UNITED STATES PATENT AND TRADEMARK OFFICE

APPLICATION NO.	FILING DATE	FIRST NAMED INVENTOR	ATTORNEY DOCKET NO.	CONFIRMATION NO.
10/718,105	11/19/2003	Grayson Morris	ACS 64865 (4144P)	9892
24201	7590	06/13/2005	EXAMINER	
FULWIDER PATTON LEE & UTECHT, LLP HOWARD HUGHES CENTER 6060 CENTER DRIVE TENTH FLOOR LOS ANGELES, CA 90045			GHERBI, SUZETTE JAIME J	
			ART UNIT	PAPER NUMBER
			3738	
DATE MAILED: 06/13/2005

Office Action Summary

FIG. 8

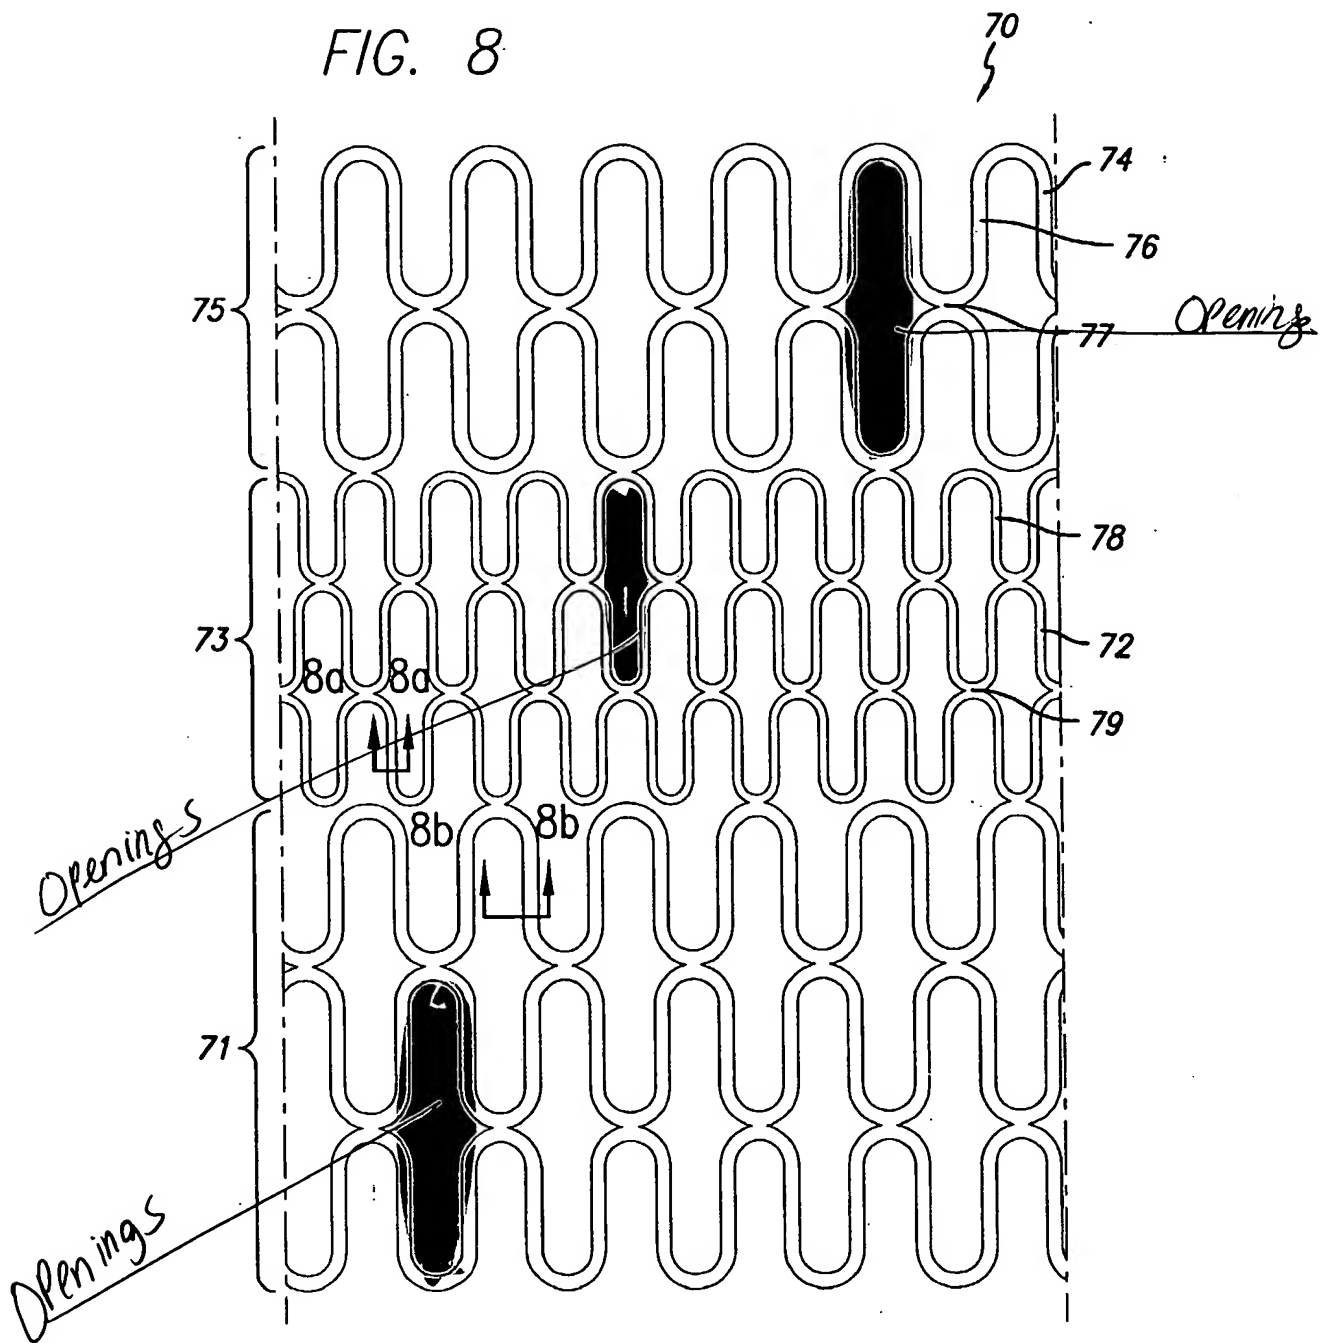
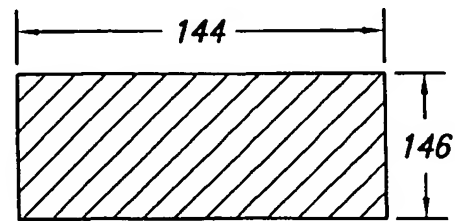
as claimed comprising: a cylindrical body having a plurality of rings (71, 73, 75) aligned along a common longitudinal axis (see figure 8); each ring having a compressed and expanded delivery state; the cylindrical body having a proximal section; a distal section and a central section (73); the proximal section having between one and fifteen rings; the distal section having between one and fifteen rings; the central section having between one and ten rings; a number of first peaks in the central section (34) differing in number of peaks in the proximal section and the distal section (count peaks in figure 8 and 10); and the plurality of peaks having a proximal end and a distal end so that the proximal end of at least one peak of the central section is connected to the distal end of at least one first peak of the proximal section by at least one link (i.e., 77, 79) it is inherent that (77, 79) are links as defined by the American Heritage Dictionary c) a single connecting element; wherein the stent is formed from NiTi [0018]; wherein drugs can be incorporated [0081]. The "openings" as claimed are formed when each ring's the out of phase peaks meet (see attached mark-up copy).

7. Claims 3, 7-10, 18-23, 25-26, are rejected under 35 U.S.C. 103(a) as being unpatentable over Cheng et al. in view of Stiger 2003/0204244. Cheng et al. has been disclosed above however Cheng's link (77, 79, 89, 99) in figures 8-10 with out of phase attachments are not linear, curved or those combinations. However Cheng et al. does disclose in other various embodiments links that are straight, curved or partially straight and curved (see 17, 15) and Stiger teaches straight links/bridges 206A that connect a first peak to a second peak. It would have been obvious to one having ordinary skill in the art at the time the invention was made to take the links (77, 79, 89 and 99) and change them to be straight or curved because Cheng states in section [0058] that the number and location of the links can be varied in order to vary the desired longitudinal and flexibility of the stent and is deemed a design modification. It is also obvious to modify the number of peaks in each section in order vary the axial stiffness of the device.
